Process Sheet

: CU-DAR001 Dart Helicopters Services

: WEARPAD

UNDER REVIEW D3535, D3537, D3564 WEARPLATES/WEARPADS

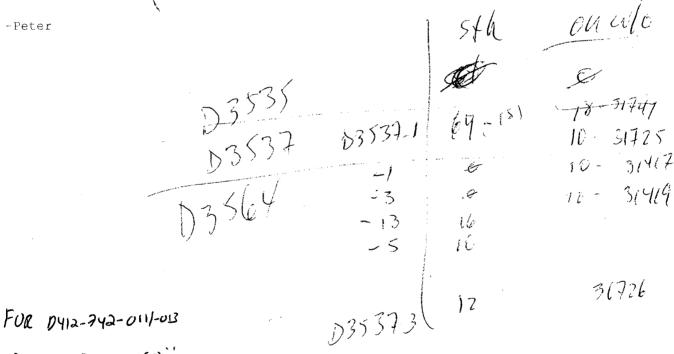
Drawings D3535, D3537, and D3564 are UNDER REVIEW. All production of the wearplates/wearpads called up on the drawings should be STOPPED.

Engineering has discovered a problem with the tabs not being wide enough when the gasket is installed underneath.

I can't understand why we are just finding out now that the flat pattern is 0.100" to 0.120" too narrow the day before we want to ship the parts. It seems to me this could have been tried with one small prototype piece on a couple sets of holes before we programmed and cut multiple parts on the waterjet. When I sign the drawings, I am assuming all of this stuff has been worked out. I would guess that the programmers are making the same assumption.

We are trying to ship a 206L/407 float skidtube with stainless steel wearplates and the rubber gasket. Upon assembly we have found that the extra thickness the gasket gives, causes a diffcult fit for the wearplate.

Jason opened the holes on the tab and the bolts not fit properly, to join the wearplates to the skidtube (see the attached pictures). We would have to open up all the wearplate tabs.

· OPEN TARS 0.060 OUTBOARD TO ALLOW JUSTALUSTOBS

0.060 REMUVE MATERIAL REMOVE MATERIAL

For future shipments the flat pattern will need to be updated.
